90-92 CONCORD
 PORTLAND, ME

STATUS: PERMIT SET

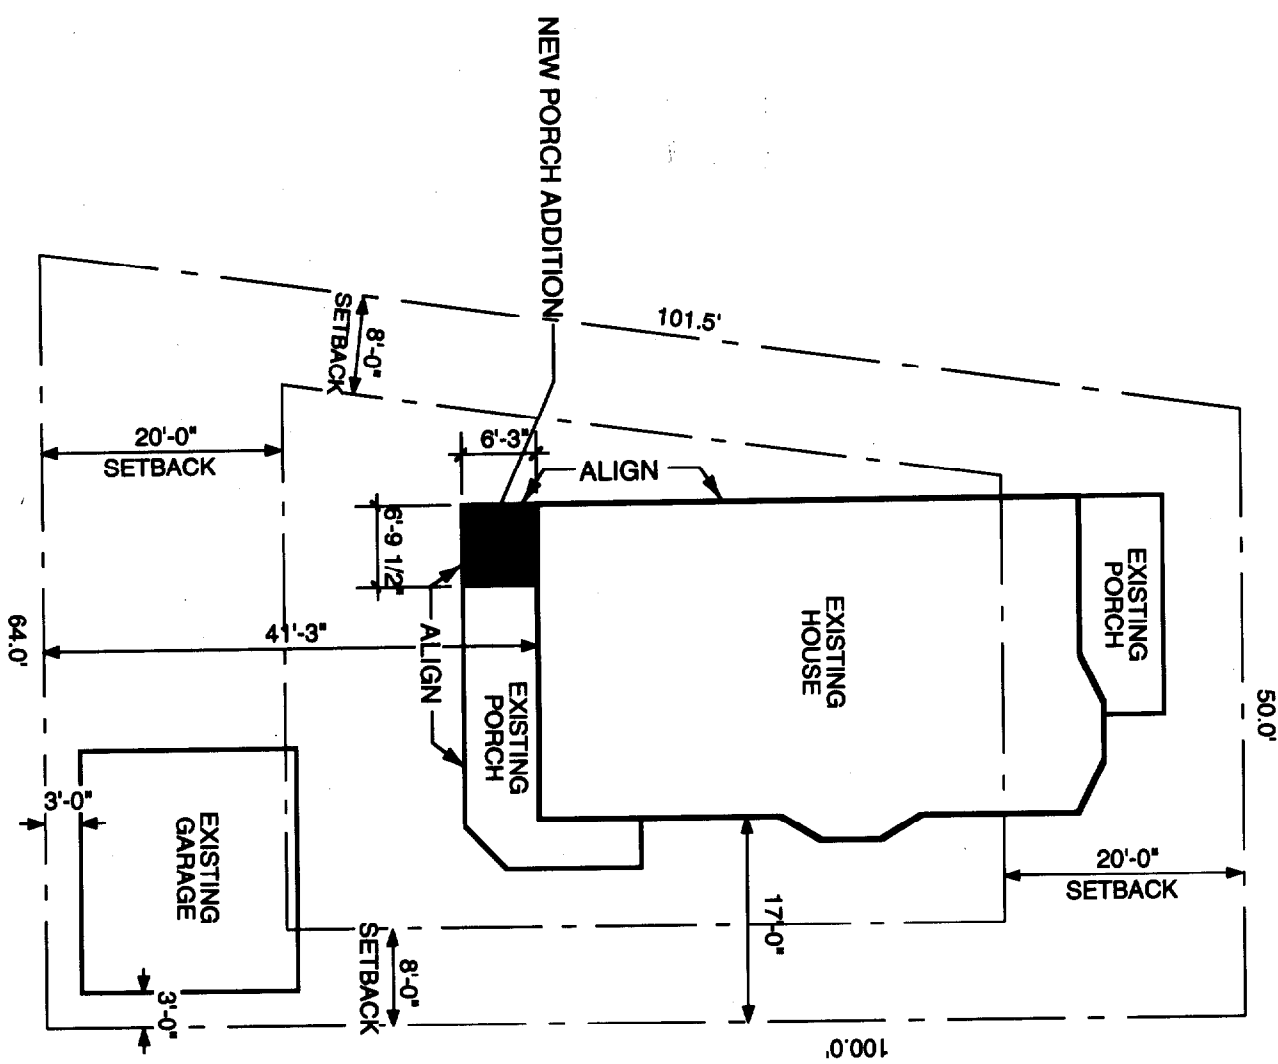
RS Zone
 Rear 20' Req 30' shown
 Side 8' Req 15' shown

A-2

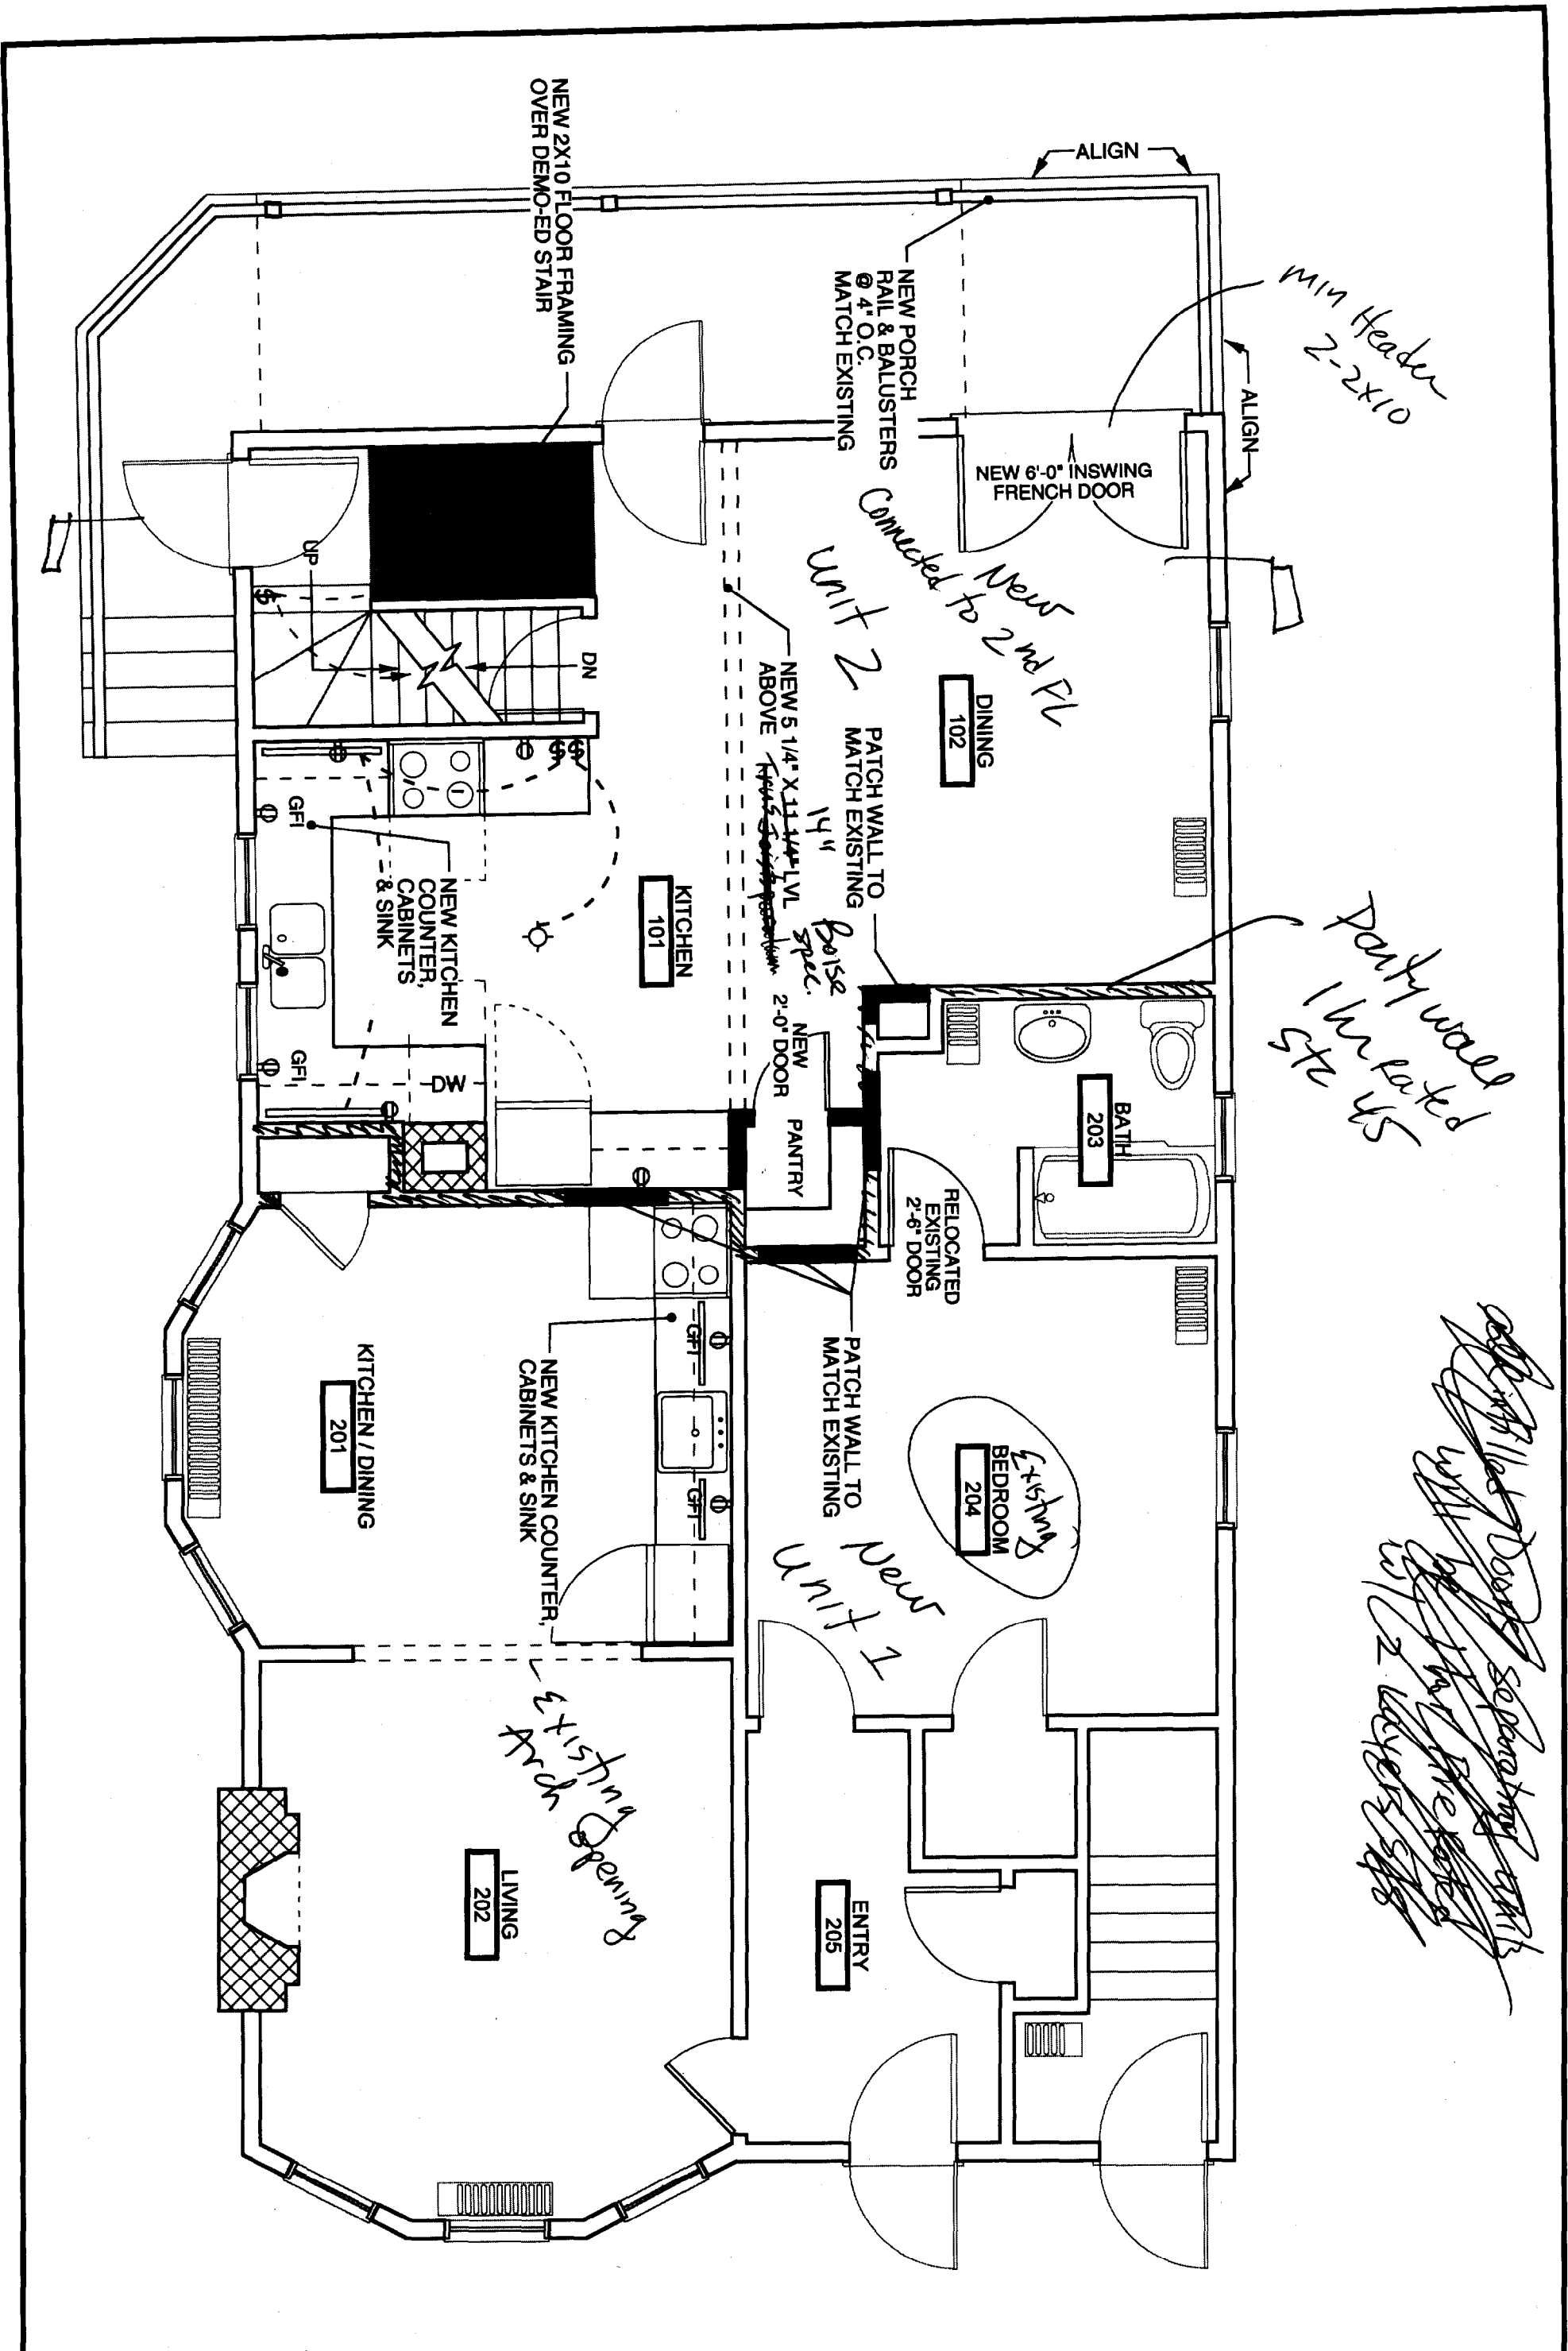
*MIN Header
2-2x10*

*Unit 2
New
Connected to 2nd Fl*

*Party wall
1 m fasted
5x12
5x8*

*Call out 11/12/03 Doors so separating unit
will be the same as
in 2 levels 5x8*

A-3

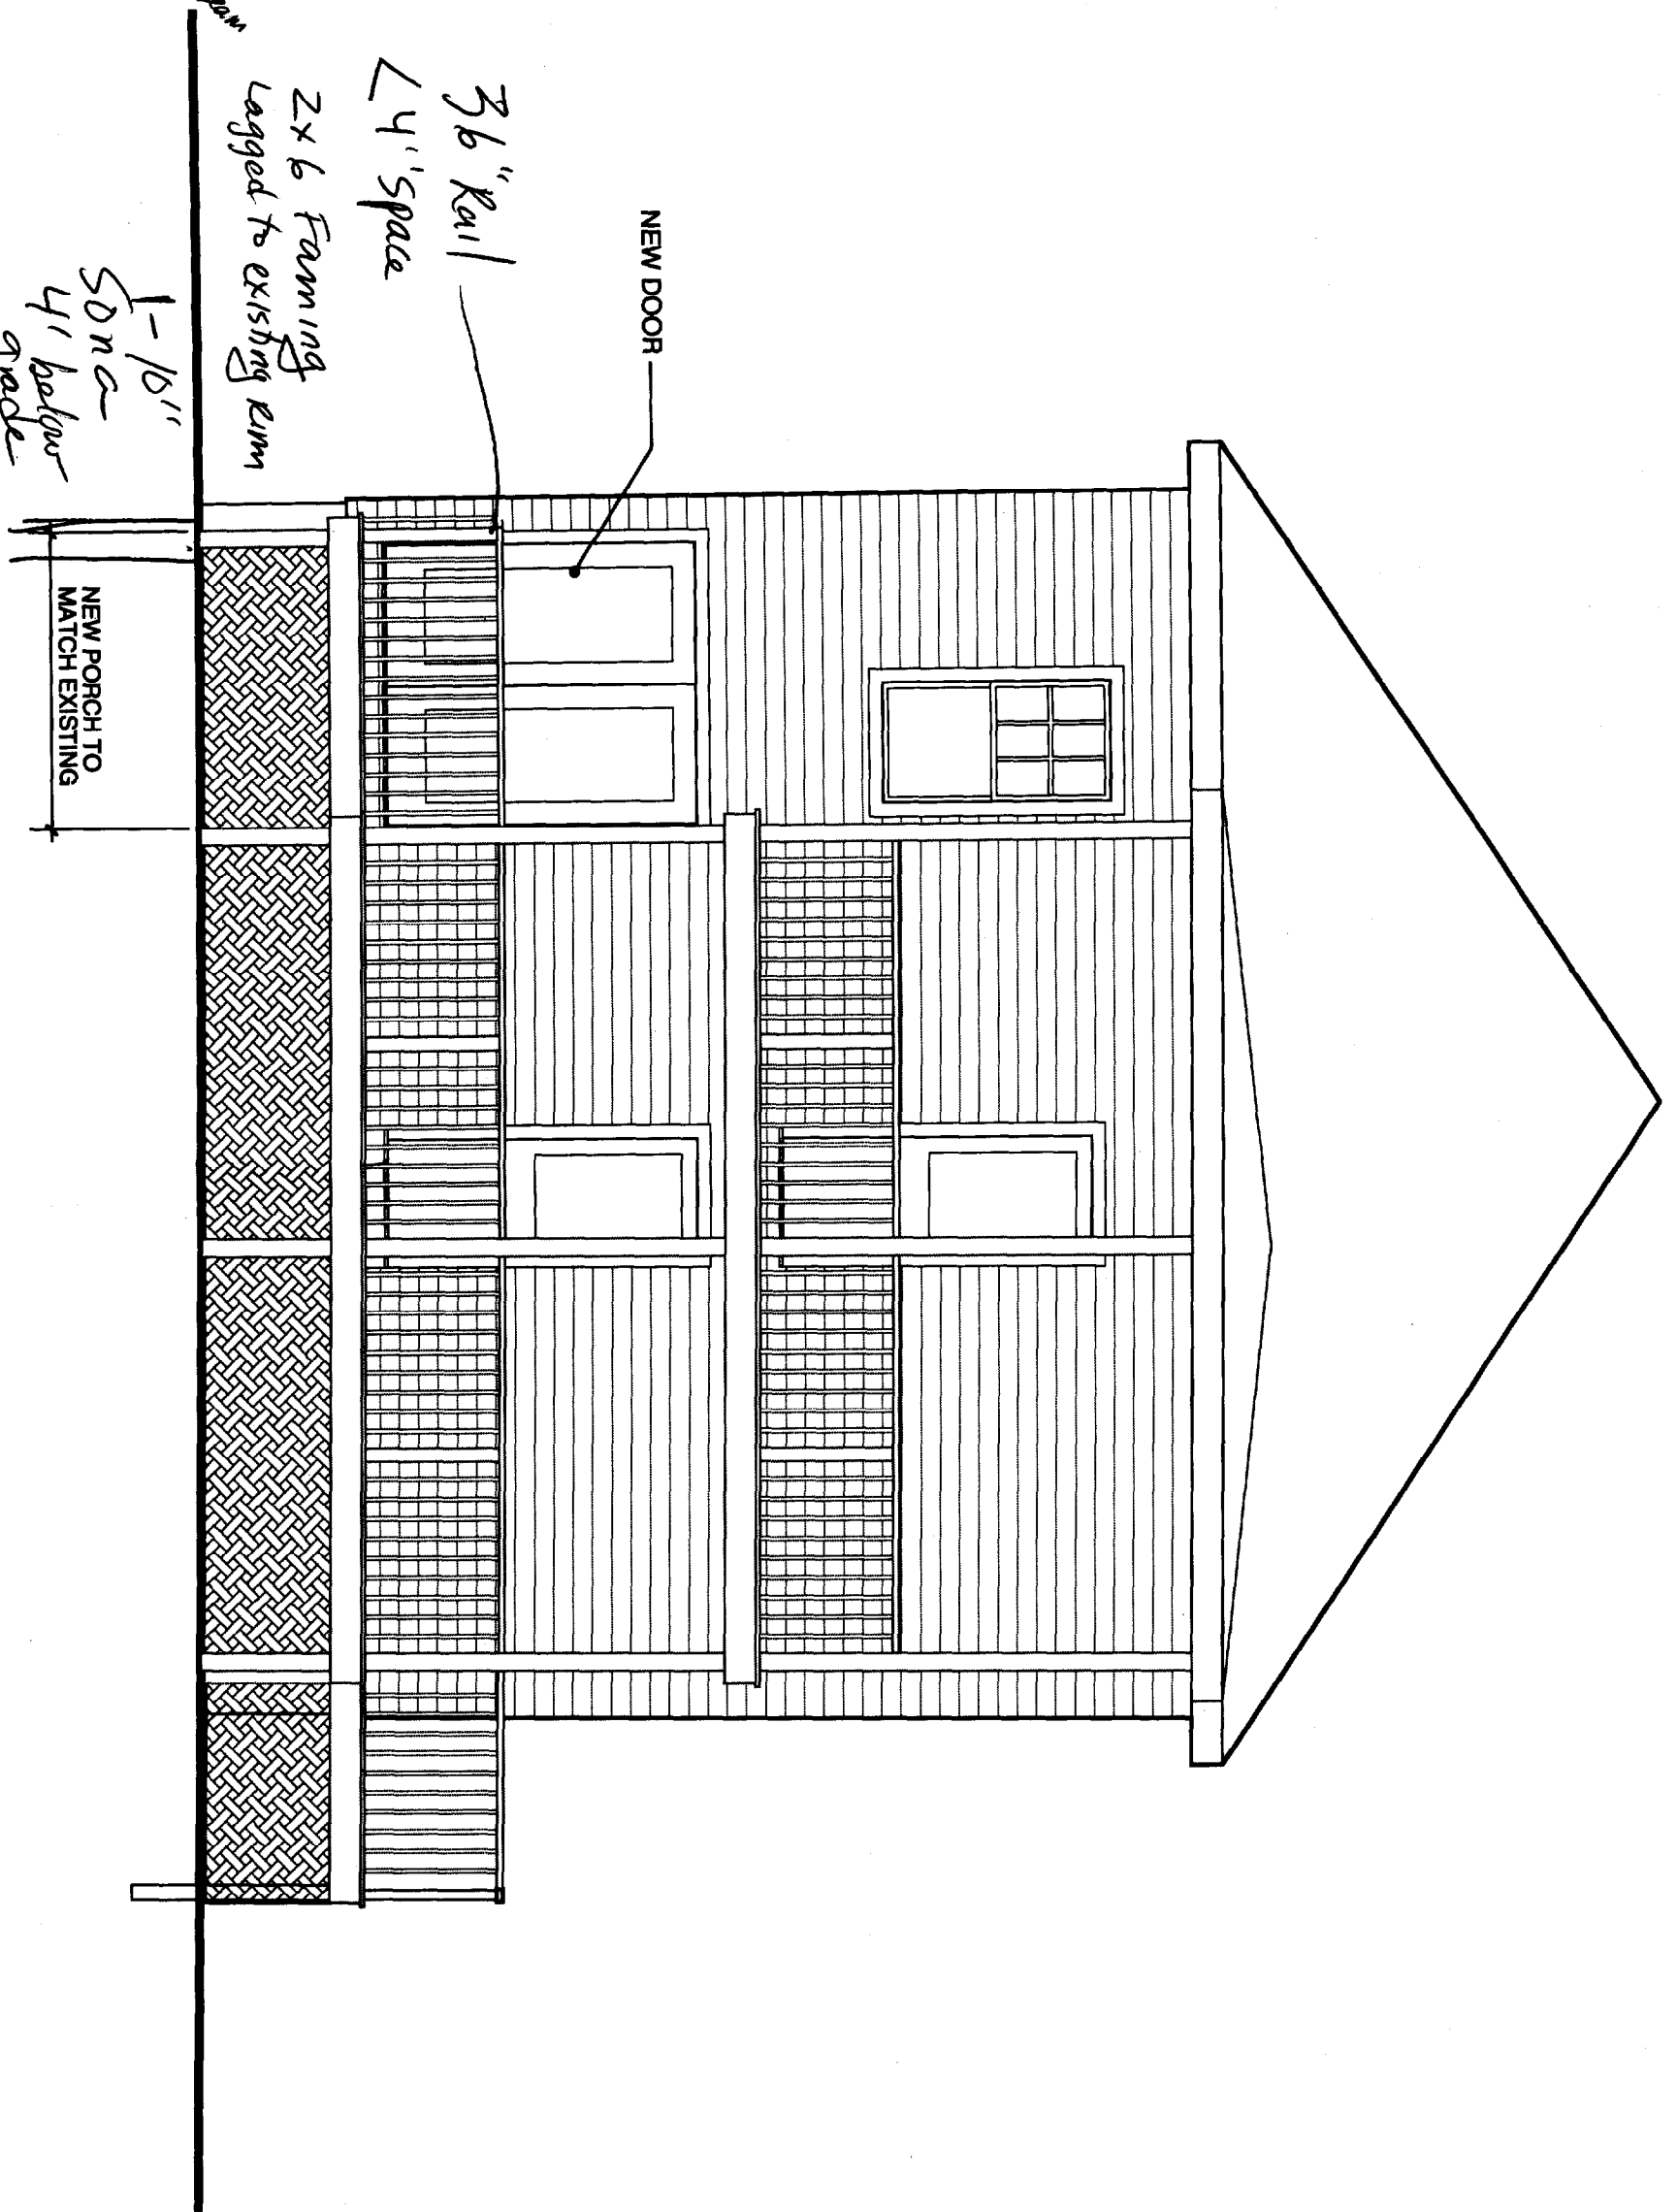
MIN.
3-2x6
or
2-2x8 Rim Beam

3x6 Rail
4" space
2x6 Fanning
Lagged to existing rim

1-1/2"
SDnc
4" below
grade
